In response to following issue raised:
1. Overshadowing.
The proposed building envelope results in additional overshadowing of nearby Special Areas (as identified in the North Sydney LEP 2001). Further envelope massing options should be prepared which demonstrate maintenance of solar access to the Miller Street Special Area and the Don Bank Museum Special Area between 10am and 2pm throughout the year, with particular reference to the Equinoxes. The options should indicate any impact on floor space and floor plate areas arising from compliance with Clause 28D (2) (c) of the NSLEP 2001.

The following envelope studies for the site at 177-199 Pacific Highway can be defined through the following keypoints:

Response to DOP letter
(30th August 2010)

Projection along Pacific
Highway

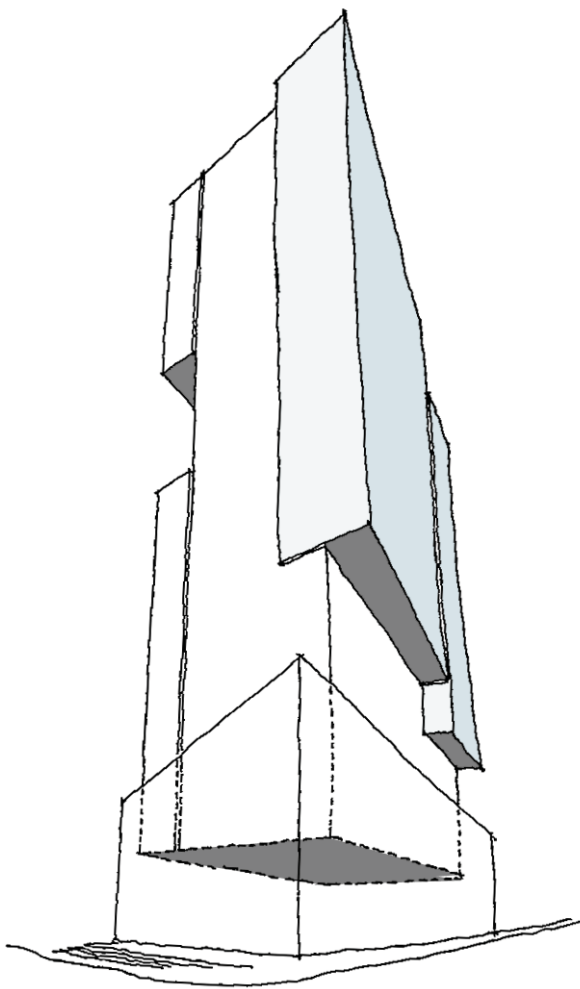
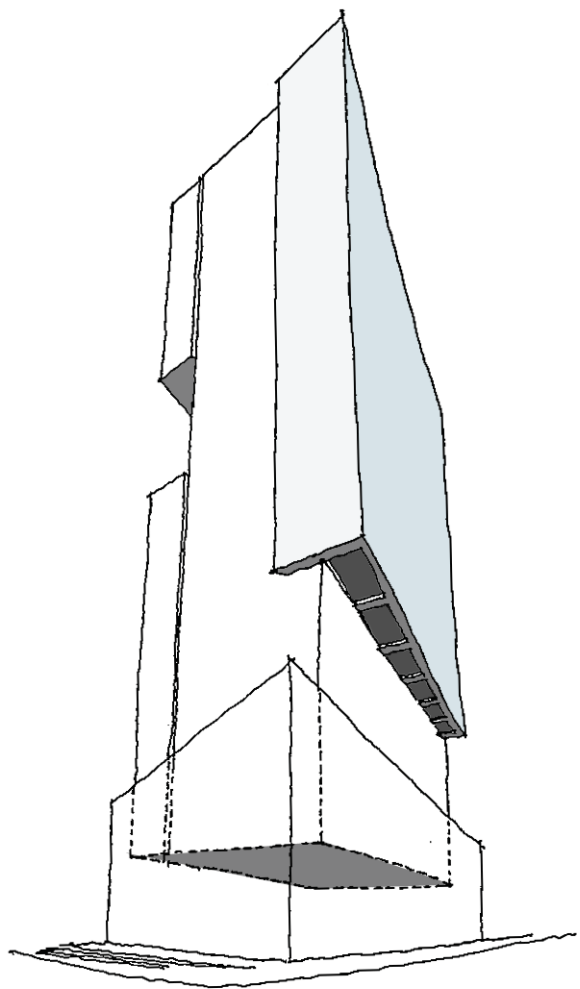
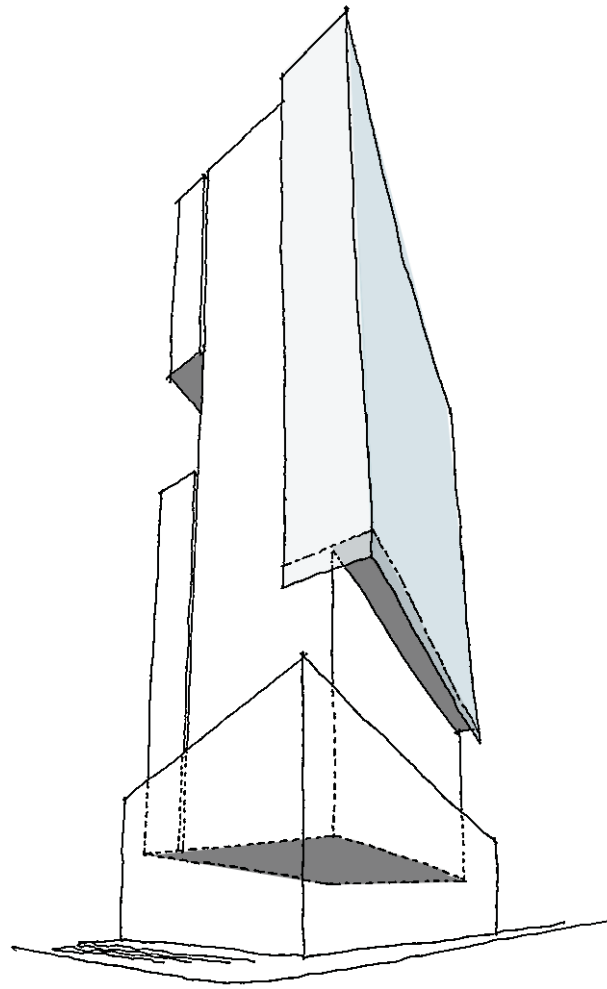
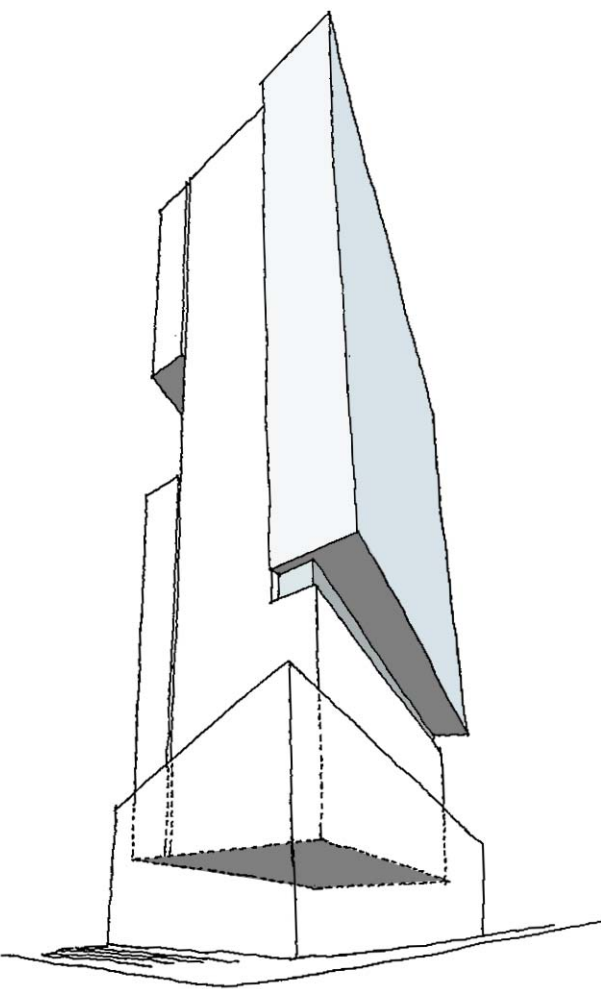
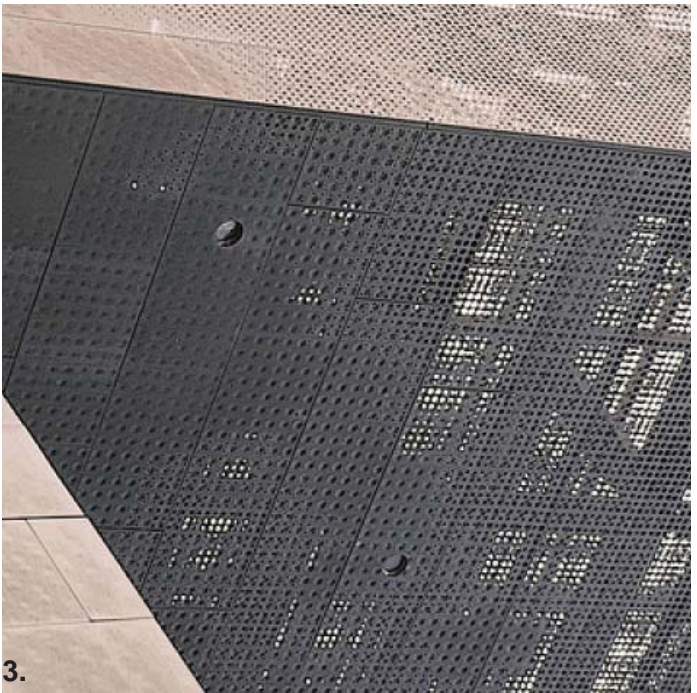
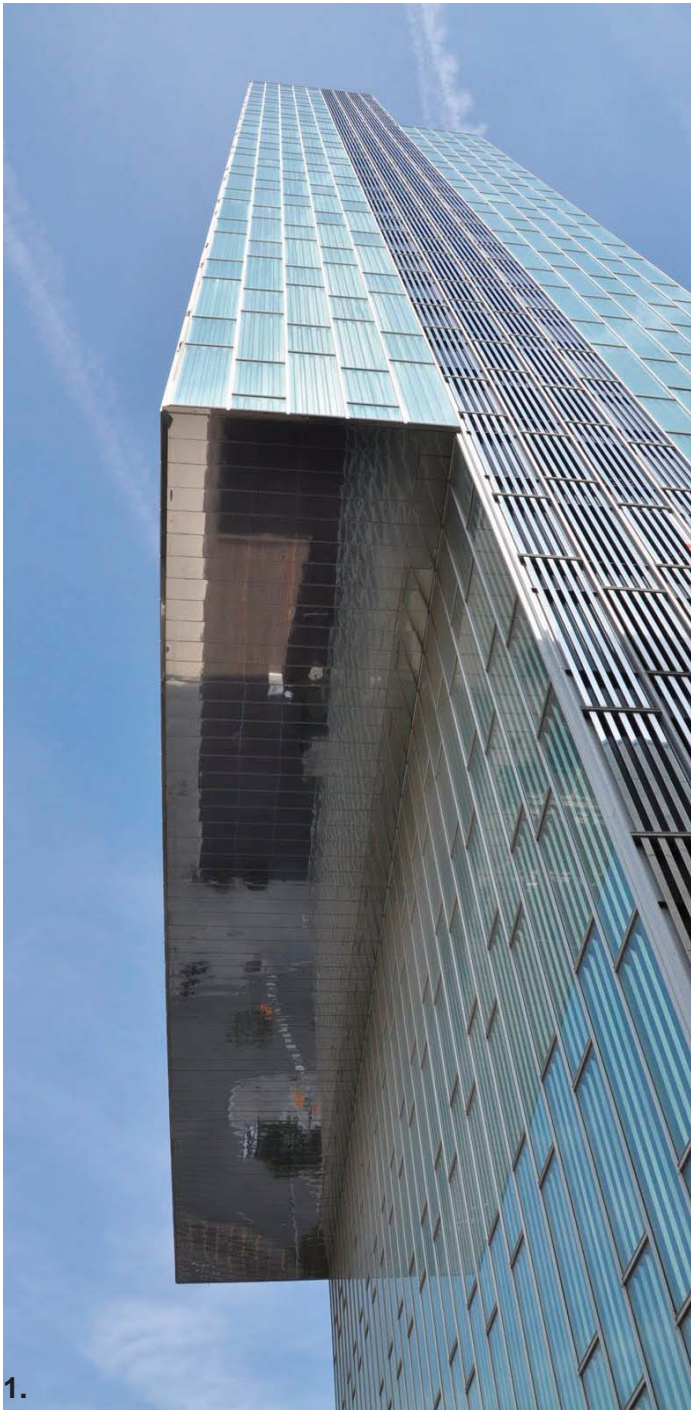
In response to following issue raised:
3. Building Form
The proposed building envelope is inconsistent with Council's setback controls on the Pacific Highway alignment of the site. Further options should be provided and should include options for the design and appearance of Level 10 soffit as seen from the public domain.

Projection along Pacific Highway
The proposed projection massing along the Pacific highway boundary could be articulated in a number of ways:

- 1. Articulated form
- 2. Expressed structure
- 3. Floating Skirt
- 4. Recessed floor for articulation of form
